Regulation No. 107

Provisions for driver's workplace

Proposal for amendments to Regulation No. 107

Proposal submitted by the expert from France

"Figure 30

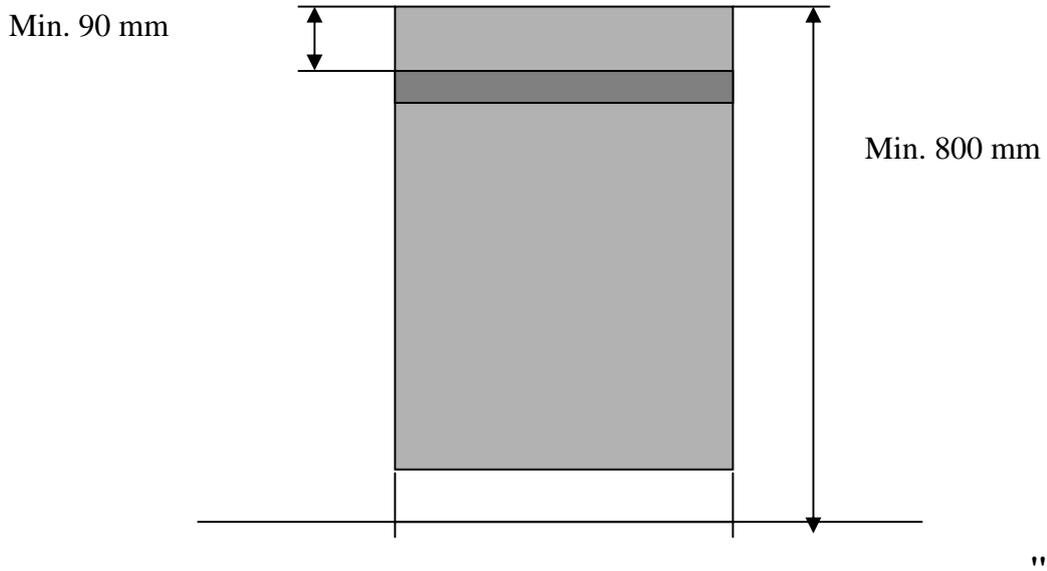
7.7.13.1.3. the vehicle is fitted with a guard complying with the requirements specified in paragraphs 7.7.13.1.3.1. to 7.7.13.1.3.3. (see annex 4, figure 30).

7.7.13.1.3.1. The minimum height of the guard measured from the floor on which the passenger's feet rest shall be 800 mm.

7.7.13.1.3.2. The width of the guard shall extend inwards from the wall of the vehicle at least as far as 100 mm beyond the longitudinal centre line of the innermost relevant passenger seat, but in any case shall extend at least as far as the innermost point of the driver's seat.

- 7.7.13.1.3.3. The distance between the uppermost edge of an area destined to hold any object (e.g. a table) and the uppermost edge of a guard shall be at least 90 mm.

Annex 4, insert a new Figure 30, to read:
